ENGINEERINGUPDATE

NO: Rel - 198 PRODUCT: G6S – Signal Relay

DATE: December 2017 TYPE: Modification – Production Location Change

G6S Signal Relay - Production Location Change

G6S Details of the Changes:

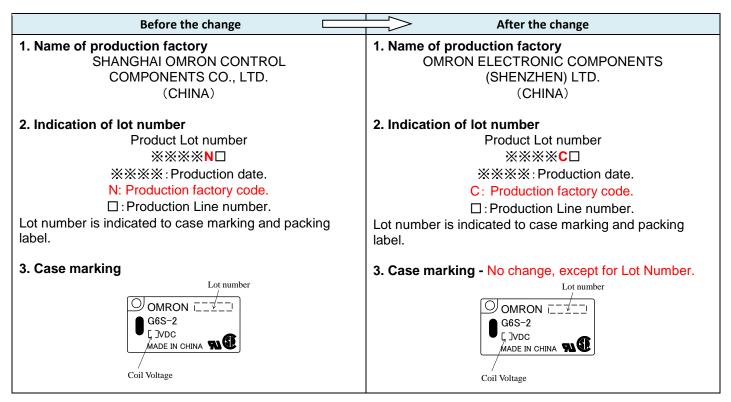
In an effort to enhance our production process, Omron will change the G6S Signal Relay production location effective as of our production in October 2018. The relay production location change will not alter the technical specifications or external dimensions of the relay. The models to be affected include, but are not limited to the models listed below; should you have any additional questions, however, please communicate with the Relay Product Specialist.
